Millstone Nuclear Power Station, Unit 3
NRC Chemical Engineering Branch (Fire Protection)
Review Meeting, March 28, 1984

Status of the NRC-CMEB (Fire Protection)
Draft SER Open Items Discussed at the Meeting
with the NRC-CMEB March 28, 1984

Responses to the Draft SER Open Items

SEE SKETCH 'D'

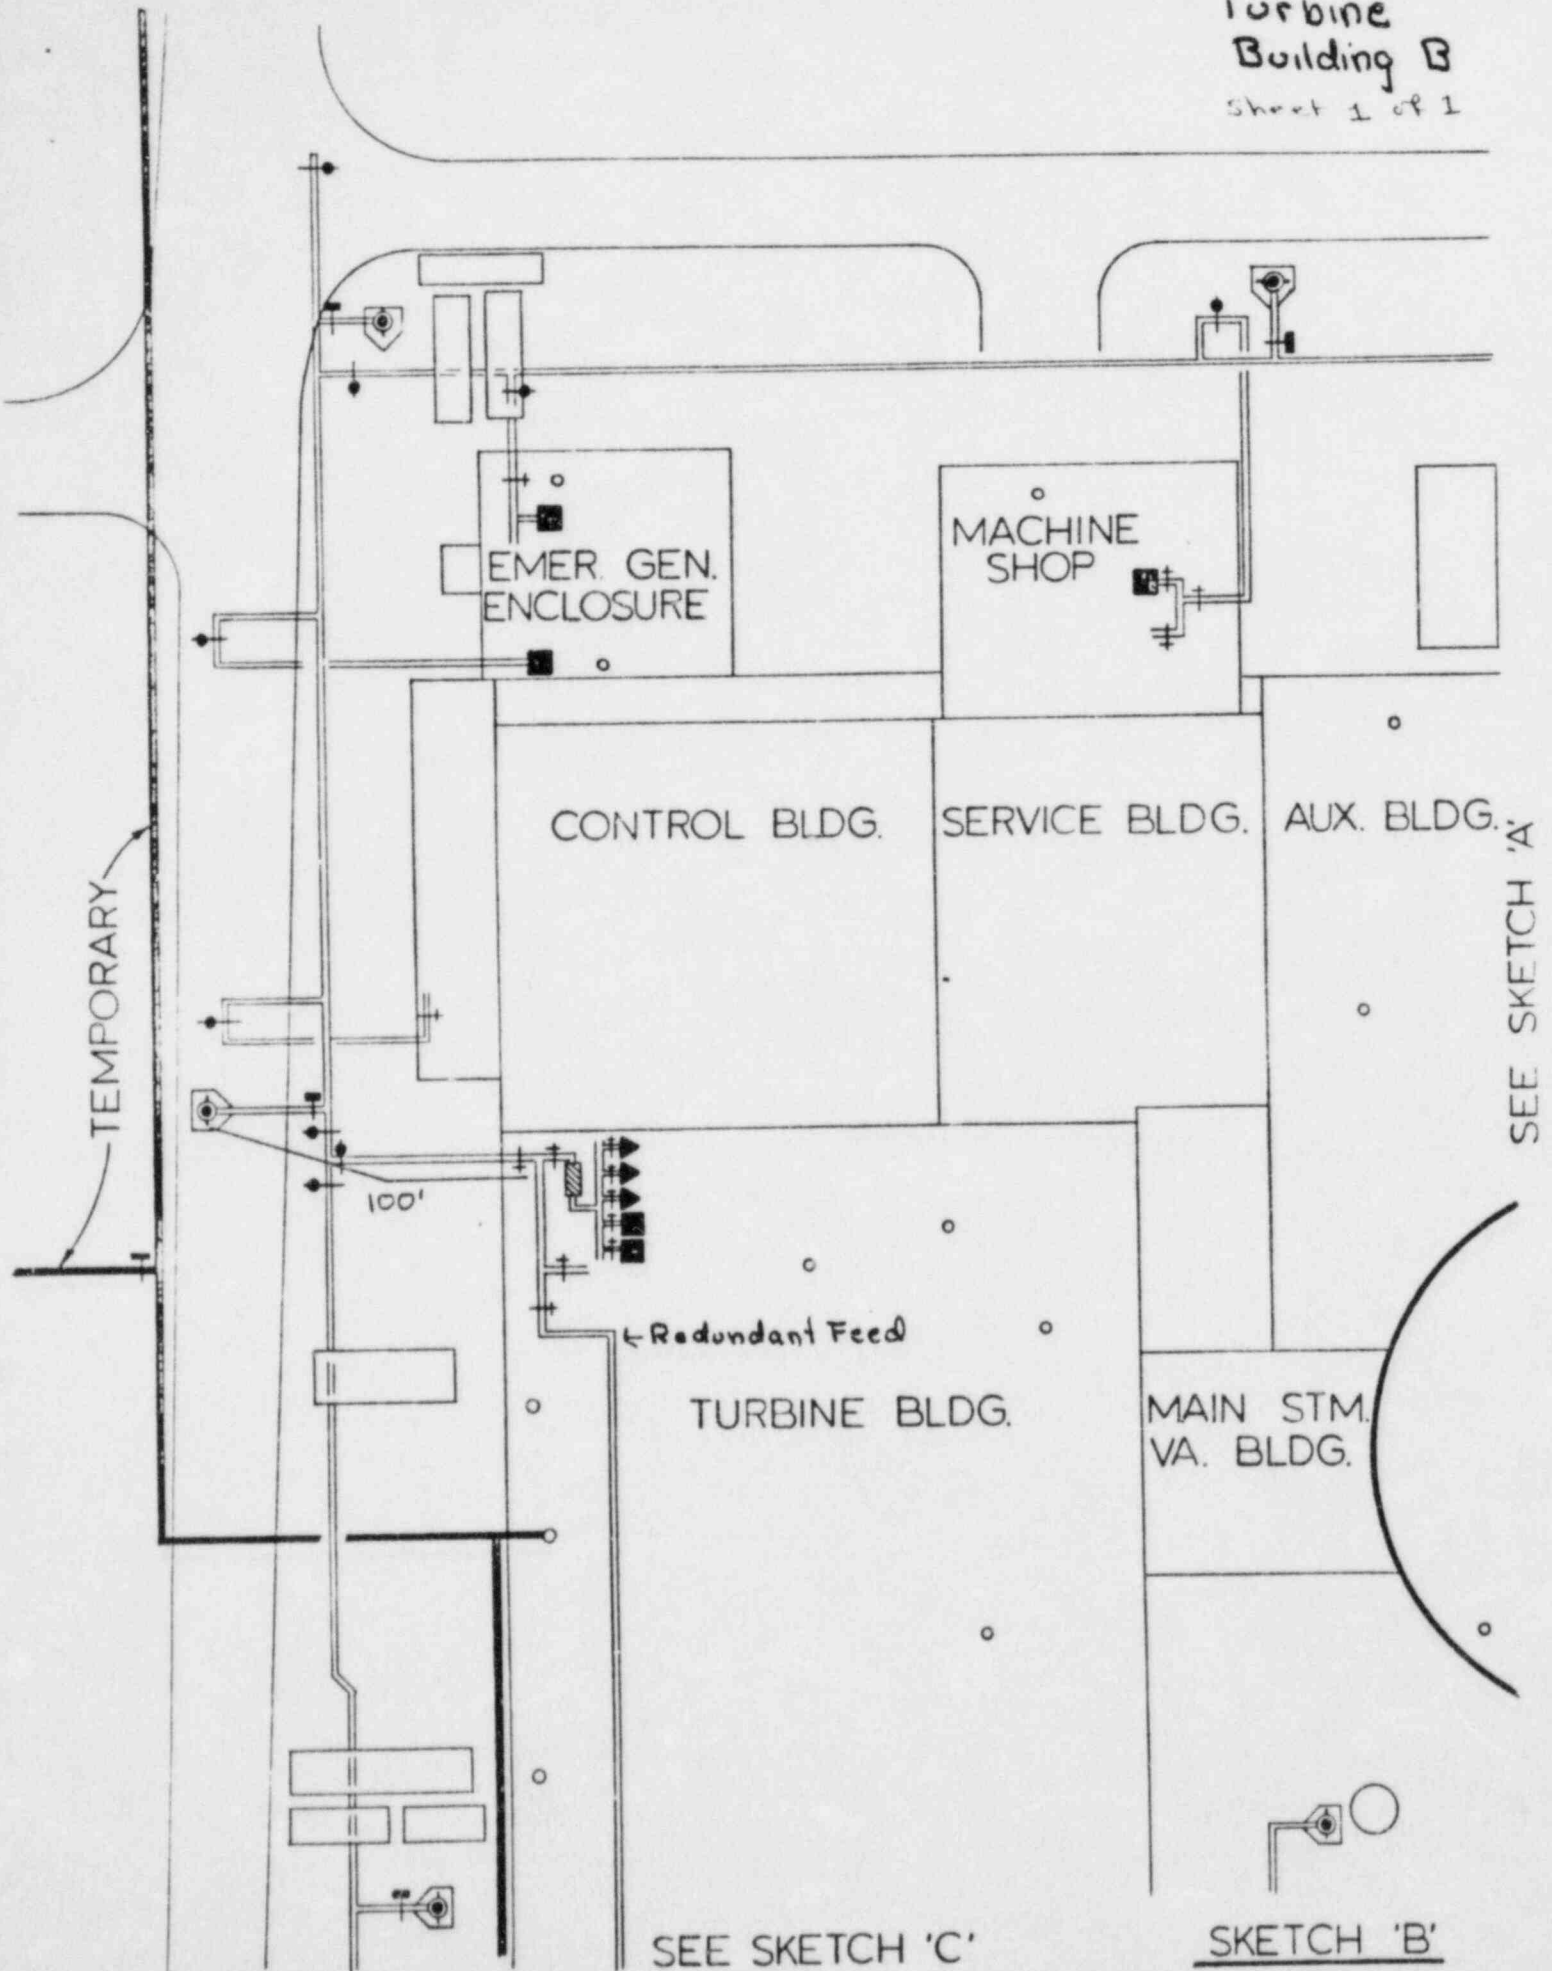
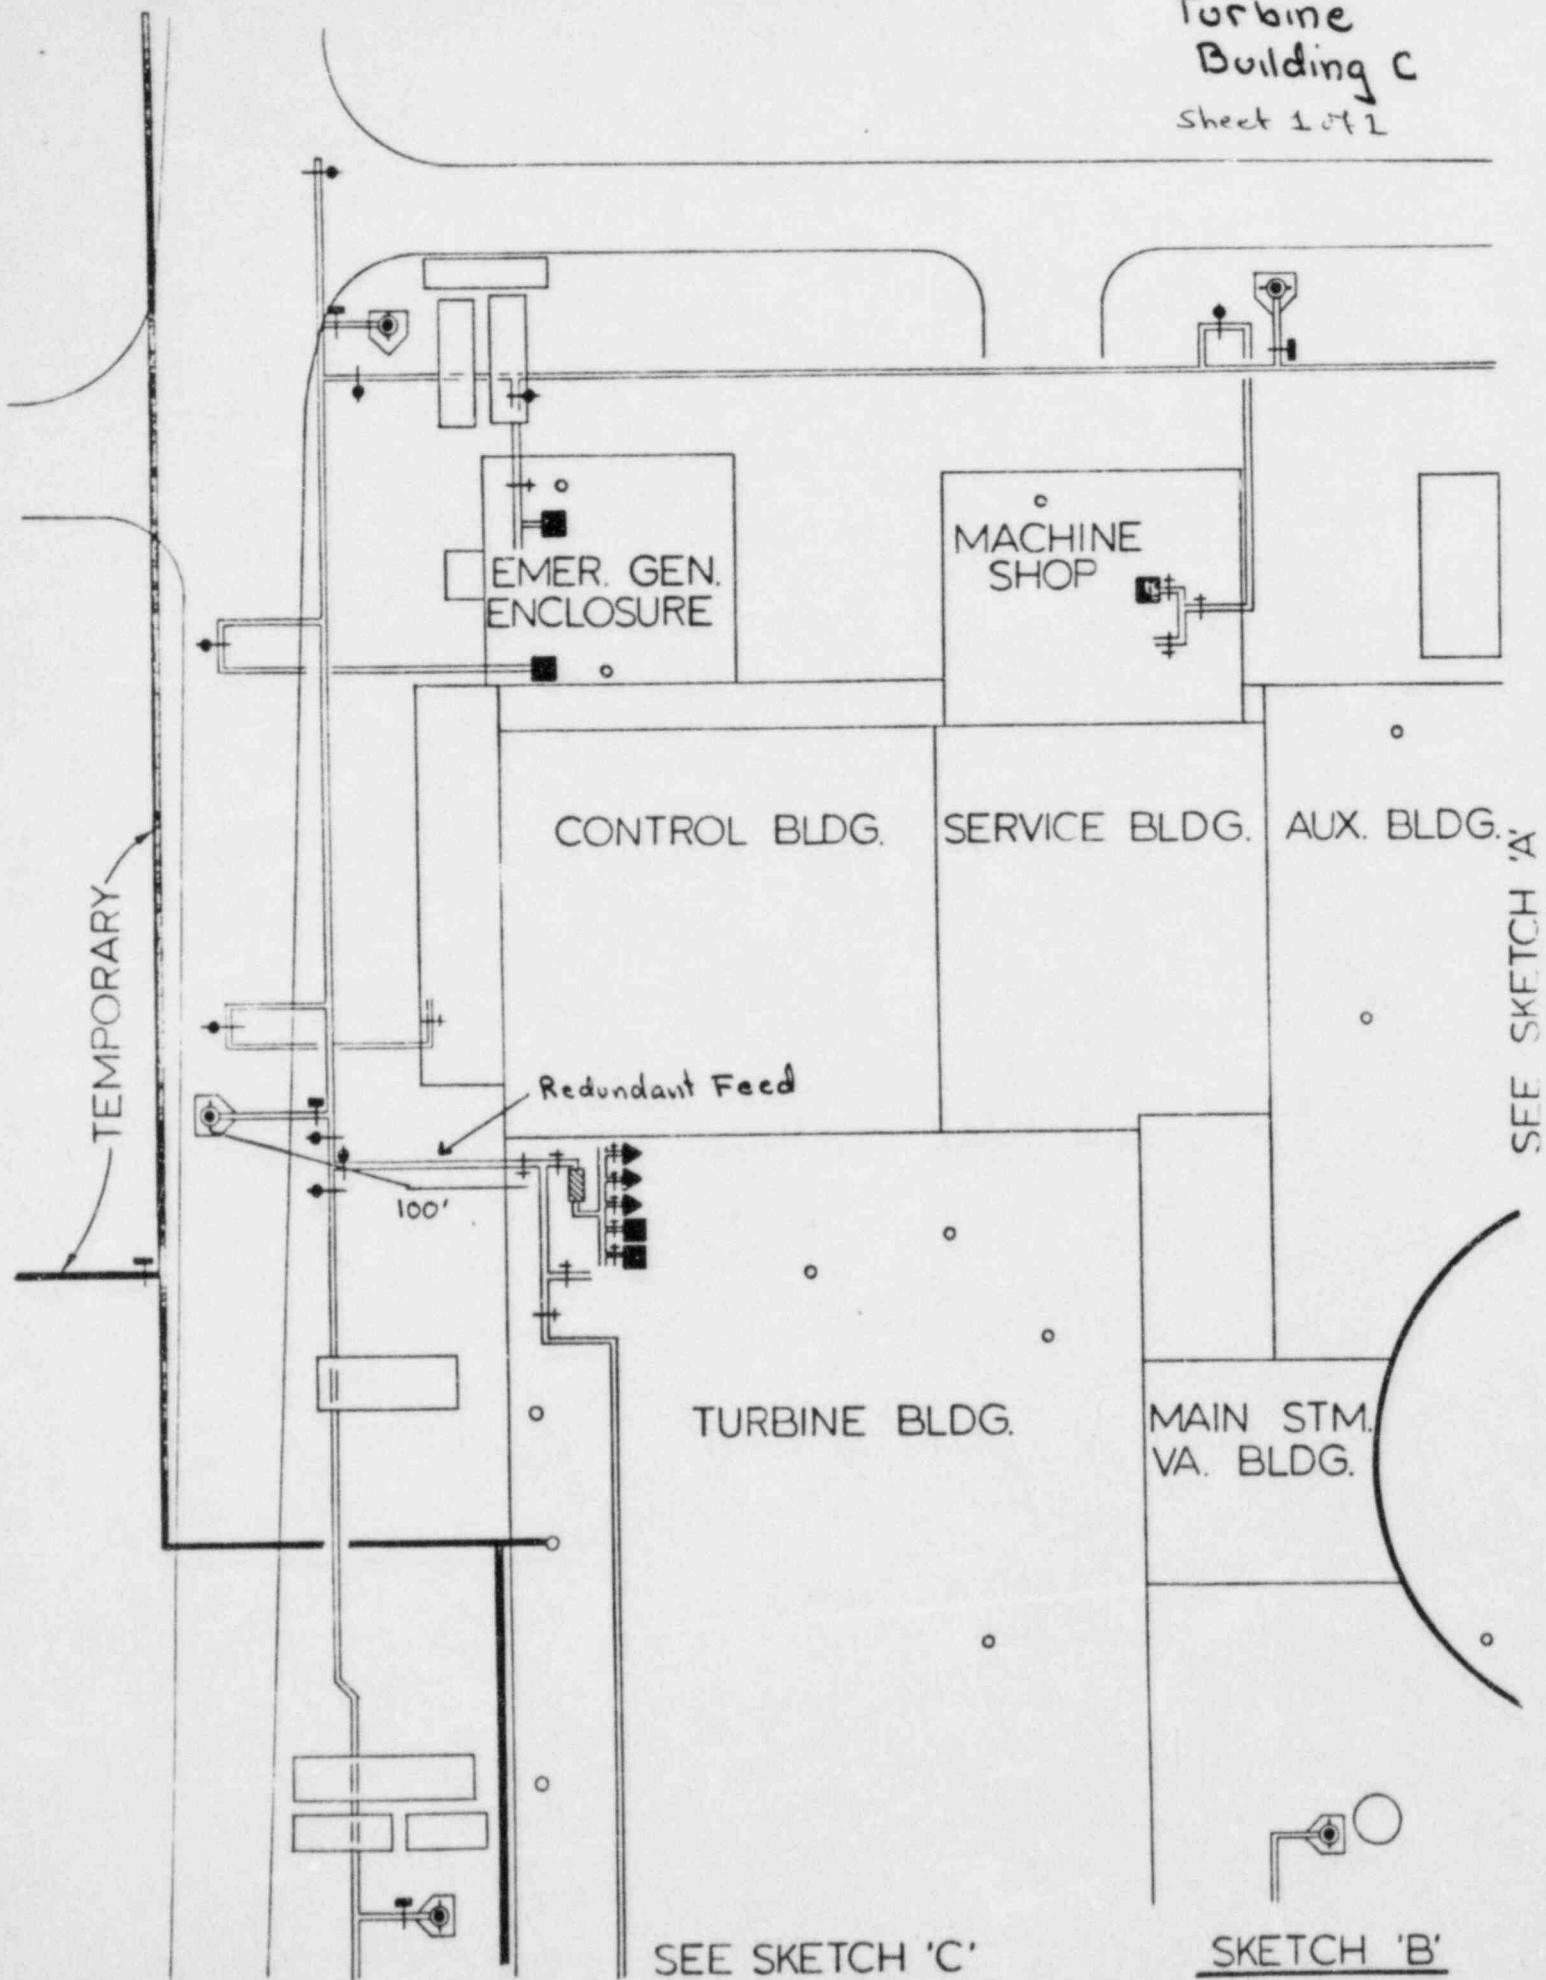
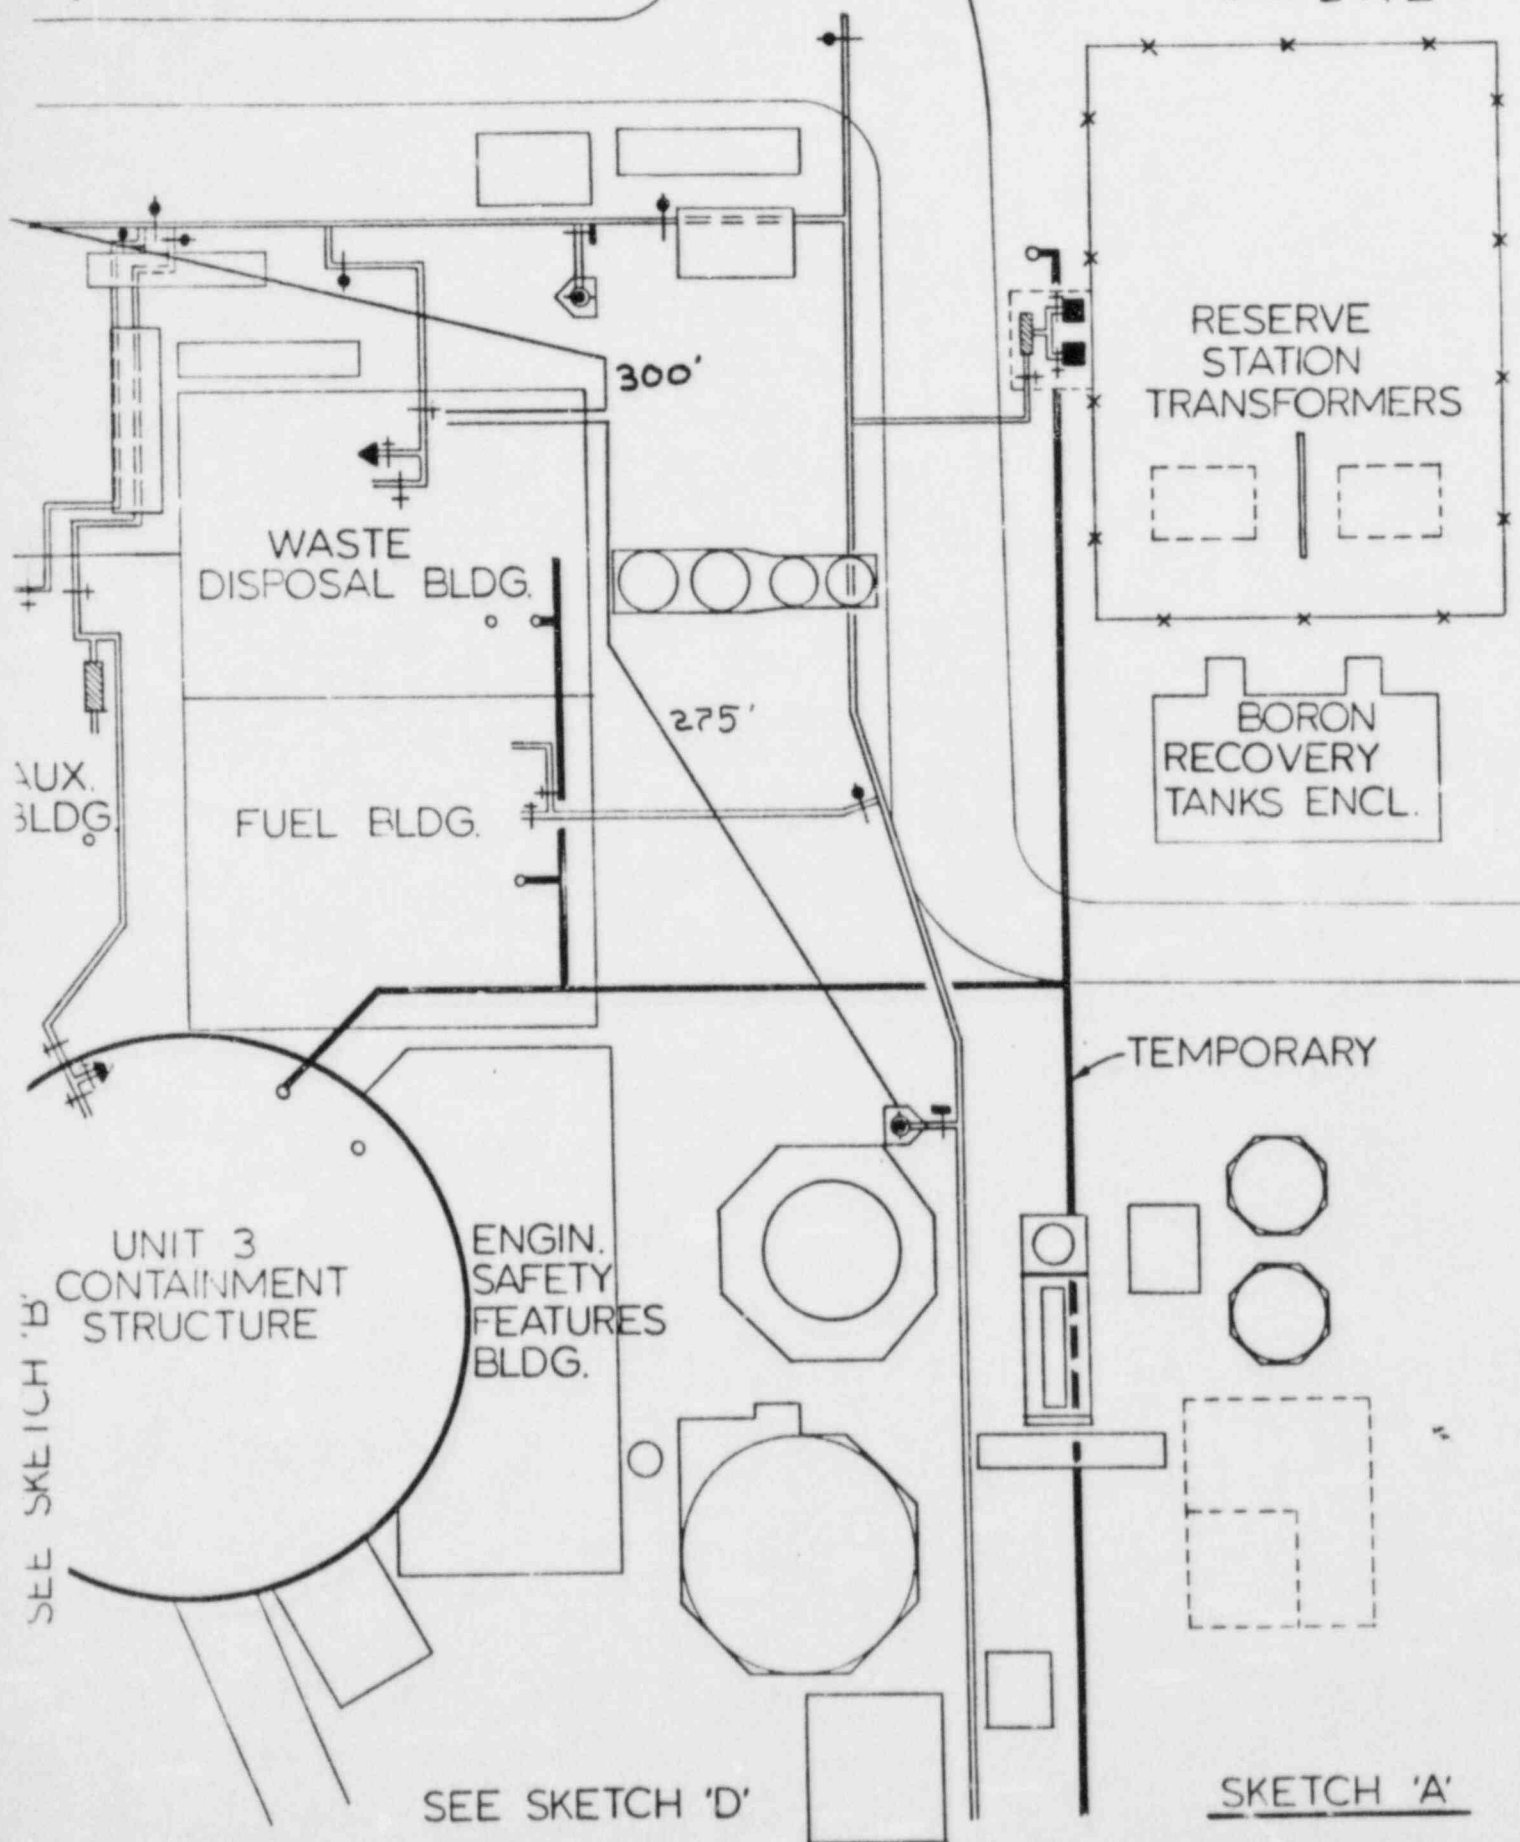
We will require the applicant to provide a fire protection water supply for the emergency generator enclosure, service building, waste disposal building, containment and the auxiliary boiler room such that a single break or failure in the supply piping will not result in the loss of both the primary and secondary water supplies. This is an open item.

The design of the underground fire water supply system at Millstone Unit No. 3, as illustrated on attached sketches A through D, is such that a minimum number of fire water suppression systems would be affected by a single break or failure. This same philosophy has also been utilized in the design of the plants interior fire water suppression systems. It is NNECO's concept should a break or failure occur in the fire water supply piping at Millstone Unit No. 3 to either:

- o Temporarily supply those fire water suppression systems rendered inoperable utilizing large diameter fire hose (2½ inch). Fire hose of sufficient quantity and size would be utilized to adequately supply the inoperable systems. These fire hoses would be supplied from fire hydrants connected to the underground fire water supply system that are unaffected by the break and/or failure. (See Table FP14-1).
- o Provide adequate manual fire suppression capability, in those areas affected by the pipe/break failure, by routing fire hoses from adjacent operable portions of the fire water system.

1. Those portions of the fire water supply piping highlighted in yellow are considered inoperable based upon a pipe break.
2. The primary temporary supply is the shortest route/discharge to an operable yard hydrant/water source.
3. The secondary temporary supply is the alternate source to the primary should it be unavailable.
